NEWTOWN TO CITY TRANSITIONAL CYCLEWAY
30% DESIGN ROAD SAFETY AUDIT
PREPARED FOR WELLINGTON CITY COUNCIL
13 December 2021

30% Design Road Safety Audit

Figure 2-5: Right turn movement for side roads

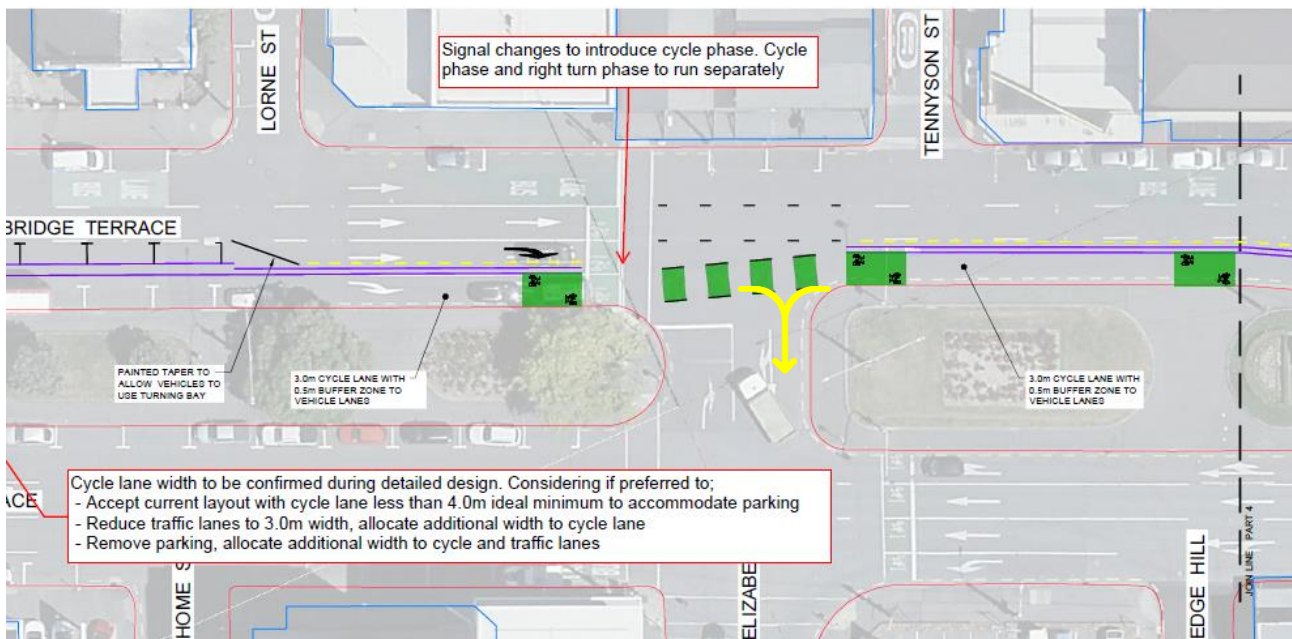
The current design does not provide suitable facilities for the turn movement into these side roads, and as such exposes cyclists to multiple lanes to cross to undertake the movement, at great risk to the cyclist.

When assessing the Cambridge Terrace / Kent Terrace segment, it is noted that the facility is in the central median of the road, and any right turn movement would occur in the middle of the intersection, a location where a right turn facility could not be installed. A cyclist undertaking the turn would be inside an active intersection without any protection or potentially signal control.

As an example, a cyclist exiting from Vivian Street would need to be positioned to the far right of the approach to the Cambridge Terrace intersection. From this position they could access into the proposed facility. However, the current design fails to identify any treatment or guidance to be provided for the cyclists. Similarly, as presented in Figure 2-5 above, a cyclist turning right from the new facility into Elizabeth Street would be required to wait at a point clear of the through movement on Kent Terrace, and within the circulating path within the vehicle cut through. This nature of facility has not been demonstrated in the current design.

Frequency Crashes are likely to be common	Severity Death or serious injury is likely	Rating The safety concern is significant
Designer response	Agree with recommendation, hook turn facilities may be appropriate in some locations	
Safety Engineer comment	Agree with Designer and SAT.	
Client decision	Agree with above. In addition, designs to consider signs to help positioning and wayfinding in and out of the facility	
Action taken	As per client decision. Hook turn boxes to be considered for each intersection and provided where appropriate.

Figure 2-6: Riddiford Street / Mein Street / Hall Street – Proposed options

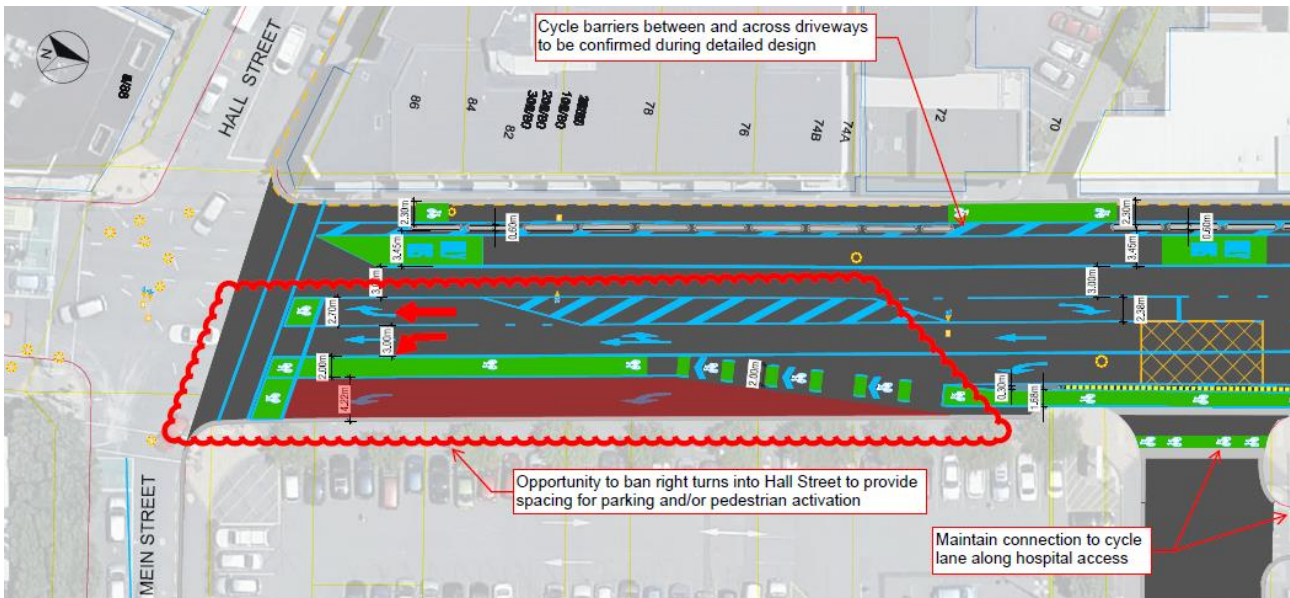
Both options include the development of a left turn facility for buses and vehicles into Mein Street. The cyclist is transferred from a kerb side separated facility, over the left turn development, positioning the cyclist between the left turn and the through lane, as indicated in Figure 2-6 below.

Dashed green boxes and cycle symbols are proposed for the cycle position transition. The nature of the symbols proposed (with sharrow arrows) would indicate that the cyclist has the dominant movement. The SAT consider that the proposed markings, while technically correct, may be unclear to the general motorist.

Frequency Crashes are likely to be common	Severity Death or serious injury is likely	Rating The safety concern is significant
Designer response	Option 1 has been chosen by the client. Risks identified by the SAT will be considered in the development of the option for 60% design. A second pre-construction RSA is expected to be undertaken. Consideration will be given to whether the weaving from bus lane and traffic lane to through lane and left lane can occur separately from the cycle lane crossing the traffic lane to minimise potential conflicts.	
Safety Engineer comment	Agree with Designer. A further RSA of the design is necessary.	
Client decision	Agree with above.	
Action taken	As per client decision, further detail to be provided for 90% design audit

Figure 2-9: Proposed additional green markings (green with red outline)

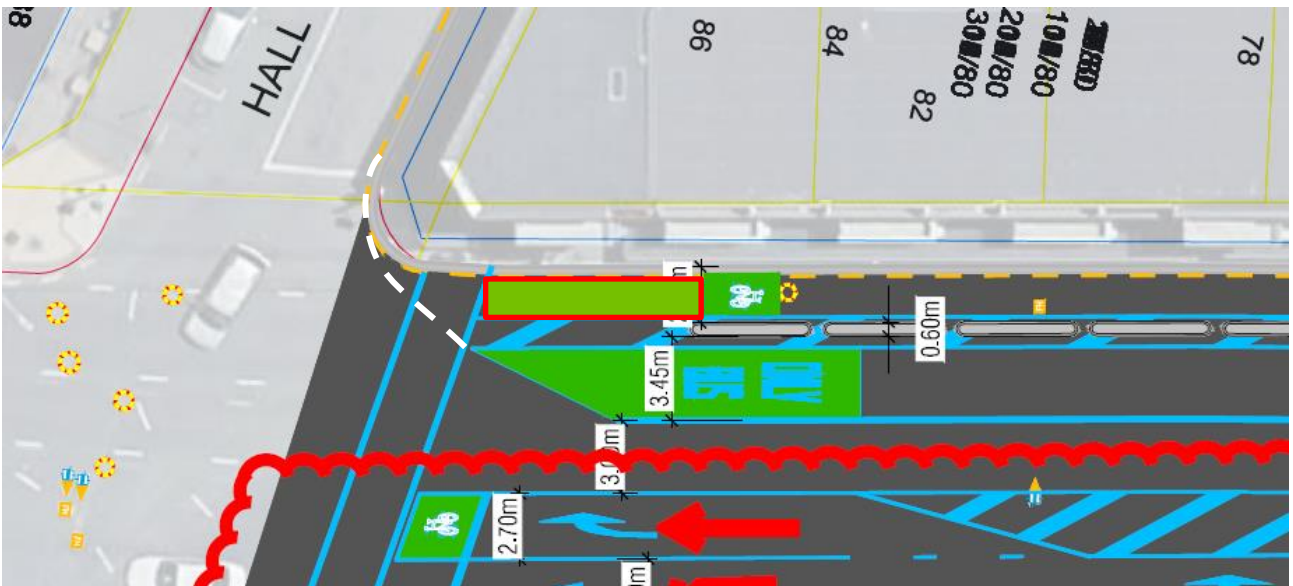
The lead for the bus lane from Riddiford Street (South) into the new design has not been shown. A review of the aerial map for the area would indicate that there is a general misalignment of the lanes, that should be corrected with lead lane lines through the intersection to correctly align the through movement into the new lanes on the north side. The current design has the green cycle markings commencing north of the pedestrian crossing lines. The SAT consider that the green markings should extend back to the pedestrian crossing lines as indicated in green with red outline in Figure 2-9.

The left turn from Hall Street into Riddiford Street (north) should be defined by the inclusion of a leading edge line to position the driver into the correct lane. This will guide the driver away from entry into the cycle and bus lane.

Figure 2-12: Proposed design alterations for mid-block crossing

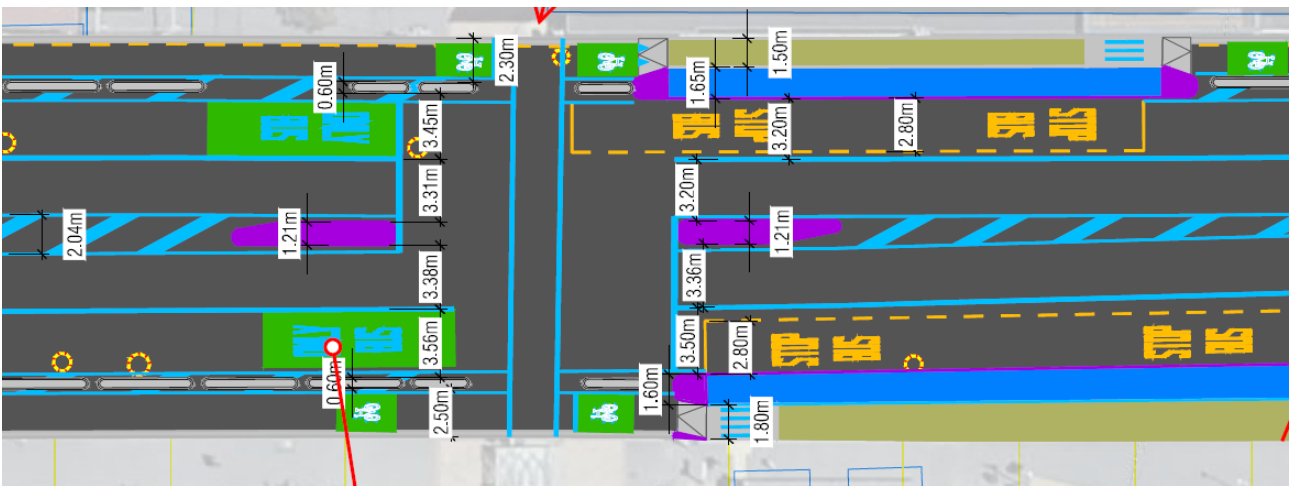
The proposed new design has a separated cycleway approaching and departing from the signalised crossing point. Immediately north of the signalised crossing, the separated cycle lane traverses onto the raised table for the bus stop. Refer to Section 2.1.9 for comments on bus stop formations.

The SAT raise the following elements with regard to the western (northbound) crossing point and cycle lane.

Frequency Crashes are likely to be common	Severity Death or serious injury is likely	Rating The safety concern is significant
Designer response	Bus stop length is sufficient for two buses nose to tail. Photo 2-10 provided by SAT indicates issue is caused by rear bus leaving a gap to exit the stop prior to the front bus. Issue to be discussed with GWRC, if rear bus exiting is required then lengthening the stop will be considered, if not, it is a driver education issue for GWRC / Metlink. Agree additional compliance measures should be considered given the proximity of the crossing and bus stops. Risks around bus and cycle pre-emption noted and to be considered further.	
Safety Engineer comment	Agree with Designer.	
Client decision	Agree with above.	
Action taken	As per above. Changes to be noted on Drawings for 90% RSA

Figure 2-15: Proposed design - Hospital Access Side Road. Conflict zones indicated

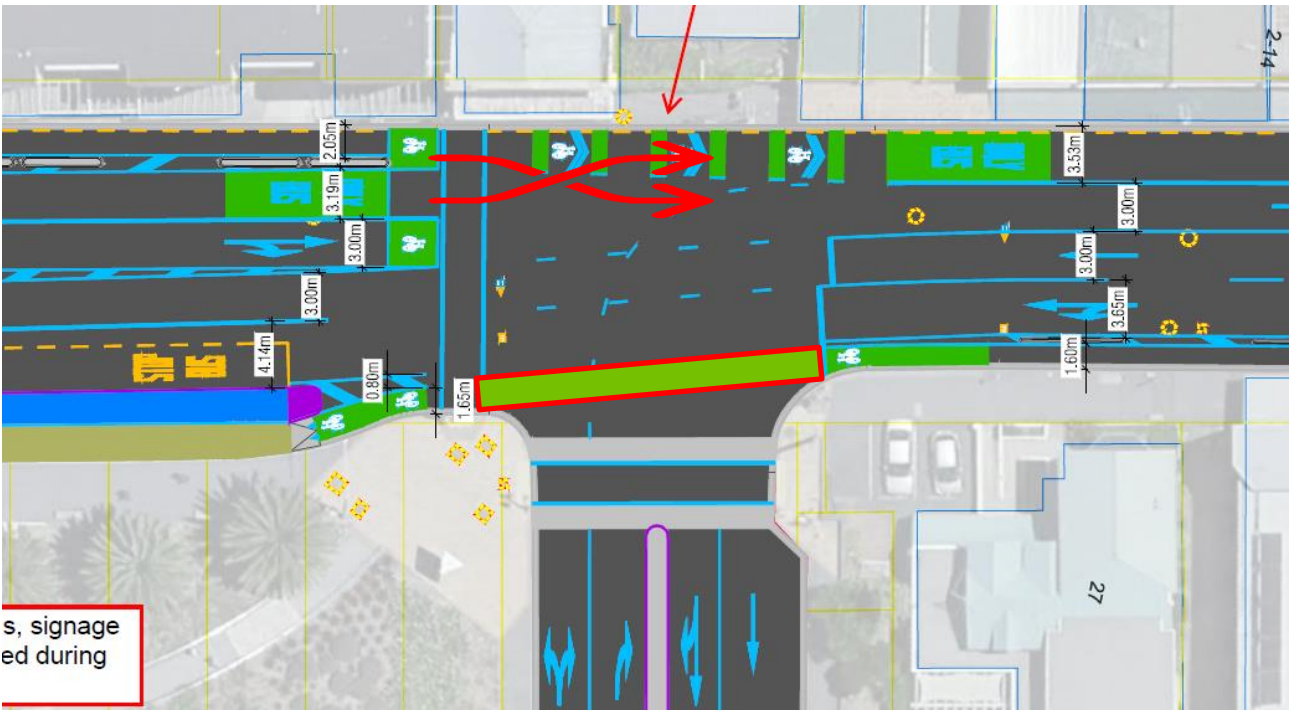
In the situation presented at the hospital access, the cyclist would be required to yield to the signal controls for the pedestrian crossing movement, and side road movement. The proposed design would have a low level of compliance with cyclists yielding due to the apparent guidance that would suggest free movement northbound.

A cyclist undertaking this movement, especially if there is pre-emption for the bus movement in the adjacent lane, would result in a cycle / bus side impact type crash, with significant injuries. The cyclist would be on the off-side for the bus driver, who may be unaware that a cyclist would be coming up on their left.

Motorists entering into and exiting from the hospital access should have clear warning of cycle movements. This should include, but not be limited to:

Frequency Crashes are likely to be common	Severity Death or serious injury is likely	Rating The safety concern is significant
Designer response	Agree with SAT that changes are required to ensure compliance with the TCD rule. A simpler approach would be to make the left lane left turn only and require traffic bound for John Street to turn into the right lane and change lanes to the left within 50m as legally permitted.	
Safety Engineer comment	Agree with Designer and SAT. Designer solution appears to be more intuitive. It decreases the likelihood of errant right turning through motorists entering the bus/cycle lane, and blocking it as they exit to the through lane.	
Client decision	Agree with above.	
Action taken	Design updated as per client decision

Figure 2-19: Proposed shared path design option - #156 Adelaide Road

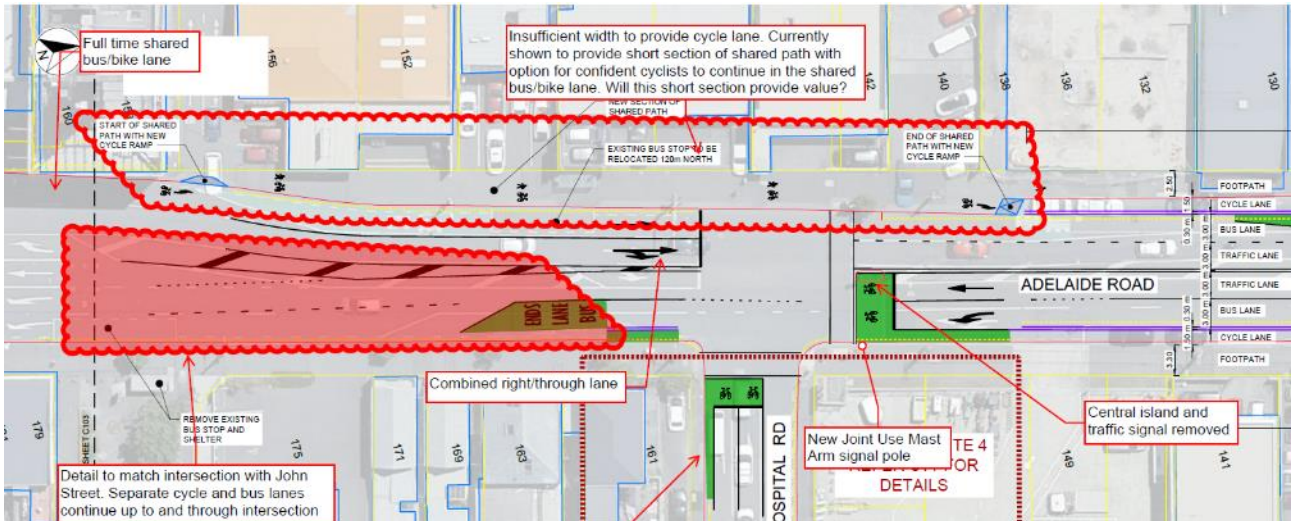
An option has been presented whereby, due to available width, the proposed cycle movement in the vicinity of #156 Adelaide Road would transition from on-road to off-road shared path for a short section, then back to an on-road arrangement, as shown in Figure 2-19 below.

With the presented design, the SAT note that the entry ramp to the facility is inadequate for the general through movement and corresponds to the location of a property access. It is considered that conflicts between the cycle through movement, and the entry / exit movement would occur.

Frequency Crashes are likely to be common	Severity Death or serious injury is likely	Rating The safety concern is significant
Designer response	Shared path no longer being considered, cyclist to shared bus lane until past the build-out.	
Safety Engineer comment	Agree with Designer.	
Client decision	Agree	
Action taken	As per designer response, drawings updated

Figure 2-20: Proposed changes to the mid-block crossing - #104 Adelaide Road

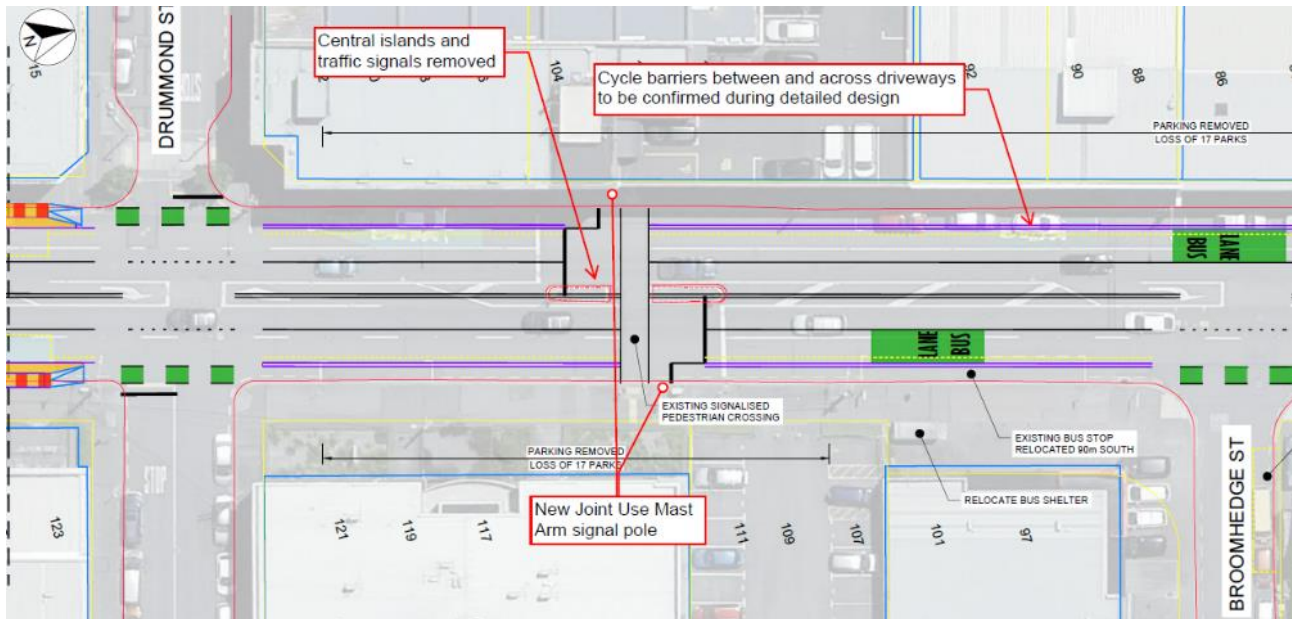
The proposed design has the central Islands to be removed, resulting in a single crossing phase over 4 traffic lanes and two cycle lanes. There is a risk that cyclists would fail to yield to the signalised crossing on the new cycle facility, as presented in previous sections of this report.

The current central islands deter in part the right turn movement (southbound) into the road level car park in the adjacent building to the north. The removal of the central islands could result in drivers attempting to access the car park through a right turn movement over multiple lanes. The placement of double yellow lines on centreline on their own does not eliminate a permitted turn movement into a driveway or access.

Frequency Crashes are likely to be occasional	Severity Death or serious injury is likely	Rating The safety concern is moderate
Designer response	Agree with risks identified by SAT. Not possible to address right turn safety within available cross-section. Client will need to accept risk.	
Safety Engineer comment	Agree with Designer and SAT. WCC to provide direction to either accept risk of right turns or ensure that suitable preventative measures are designed and installed for the turn.	
Client decision	Removal of the flush median and right turn pockets apply for all business entrances and side road on Adelaide Road. There is insufficient width within this corridor to maintain this in addition to the cycle lanes. Banning right turns along Adelaide Road has been assessed but not considered practical from a servicing and network perspective due to a lack of turn around facilities. This is to be specifically monitored following installation using CCTV cameras located at The Basin, John Street and the pedestrian crossing signals and included in the monitoring and evaluation of these projects with specific interventions if required.

Figure 2-23: Proposed Design Adelaide Road to Basin Reserve

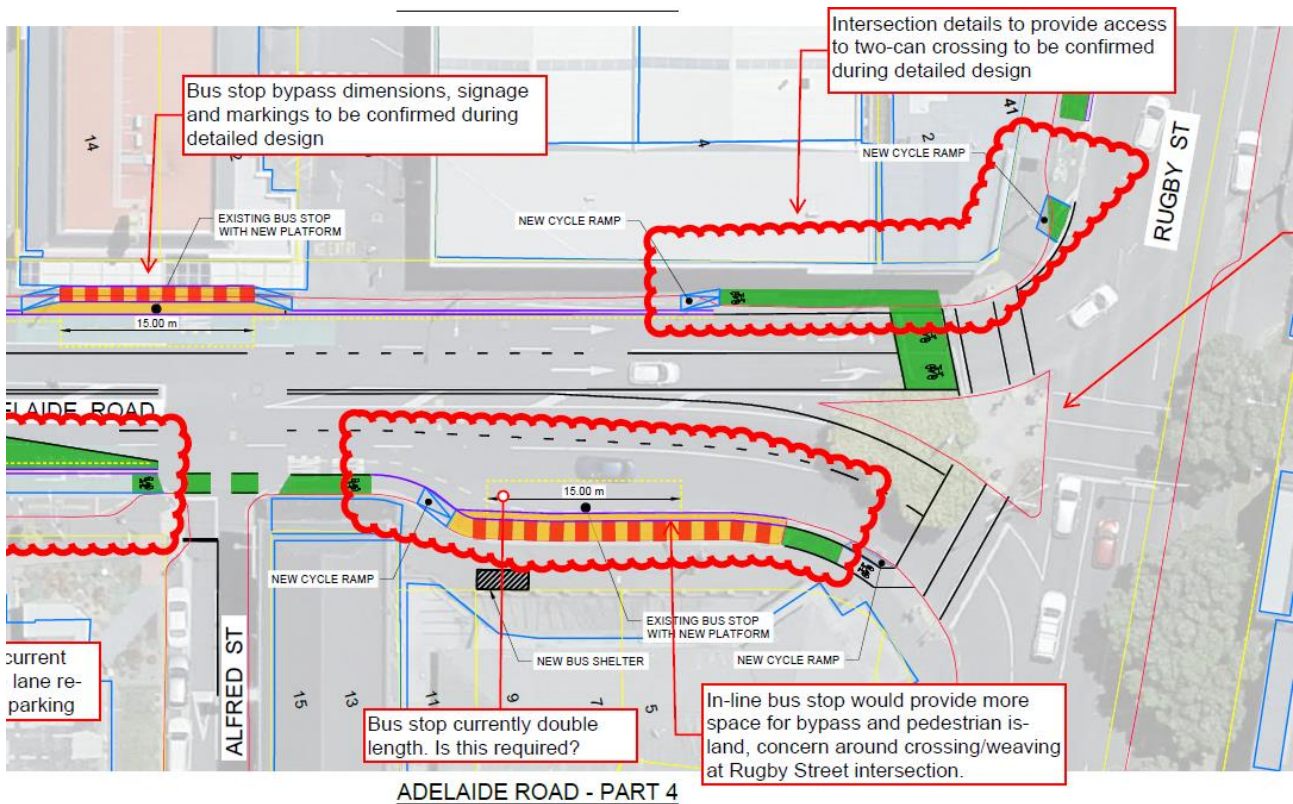
The crossing movements will occur via signalised crossing facilities to the central island. The following comments relate to both the movement from Adelaide Road towards the Basin Reserve, and the movement away for the Basin Reserve, onto Adelaide Road.

The proposed design for the facility (southbound – Adelaide Road) has cyclists traversing onto a cycle path that is in very close proximity to the bus set down area, traversing along the current kerb line. The plans indicate that the cycle facility will be at footpath level.

Frequency Crashes are likely to be occasional	Severity Death or serious injury is very likely	Rating The safety concern is significant
Designer response	Revised design for bus lane development from Rugby Street to Adelaide Road has been identified for discussion with Waka Kotahi. Agree that there are risks for active travel users with the current intersection layout. However, outside the current scope of the project.	
Safety Engineer comment	Agree with Designer and SAT. Disagree with Designer. A lower risk intersection layout design is within scope, to ensure that significant risks for active travel users can be understood and mitigated to best effect.	
Client decision	Recommendation for changes to the lane layout (1 and 2) approved by Waka Kotahi and to be included in design. Physical changes to pole and kerb locations out of scope. To be considered during monitoring and evaluation and findings relayed to LGWM for business case design Design to be further considered during 90% audit

Figure 2-34: Proposed design options – Mid-block crossing

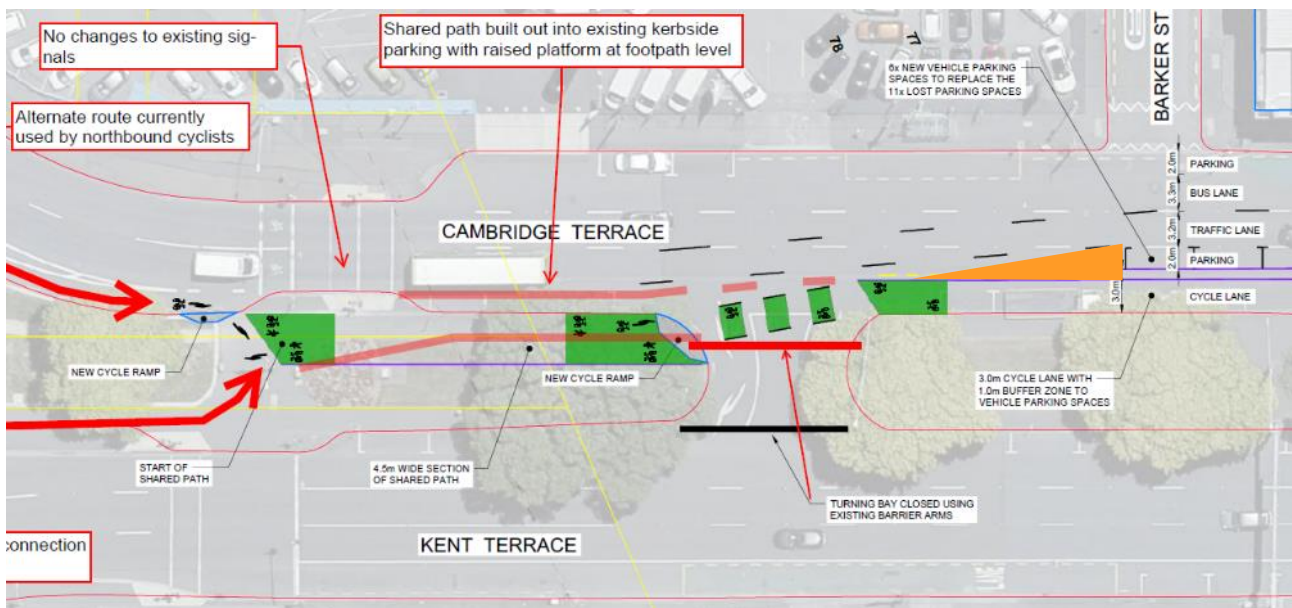
The proposed design includes some changes to the current mid-block pedestrian crossing facility near the Basin Reserve, as indicated in Figure 2-34 below.

As mentioned above in Section 2.5.1, tree roots are currently affecting the footpath surface, and would impact with the intent of the design for the green marked cycle / shared space option in Figure 2-34.

The second option (defined by red edge lines and text) would reduce the impact of the tree roots on the facility, and better define the lane edge and lane shift movement. This would also increase the landing area on the central median and could be incorporated as part of the placemaking for the Basin Reserve area. The formation of a kerb buildout (shown in orange) on the city side of the median gap would assist in the direction of both through traffic, and right turn through traffic. This would also provide protection to the approach side of parked vehicles.

The current design does not identify with detail the proposed controls to be formed as part of the route. The SAT consider that this is a critical element as failure to yield at the turn through locations could result in serious injuries to vulnerable users. As detailed previously, the new formation may be considered more attractive to pedestrian and vulnerable users, and a lack of suitable controls, especially over wide turn lanes, could result in conflicts and impacts with vulnerable users.

Frequency Crashes are likely to be occasional	Severity Death or serious injury is very likely	Rating The safety concern is significant
Designer response	Agree further work required to develop the path route through this area. Note that the turn-around facility is proposed to be permanently closed as part of this project.	
Safety Engineer comment	Agree with Designer and SAT.	
Client decision	As per designer response, further detail to be included in 90% designs	
Action taken	As per client decision
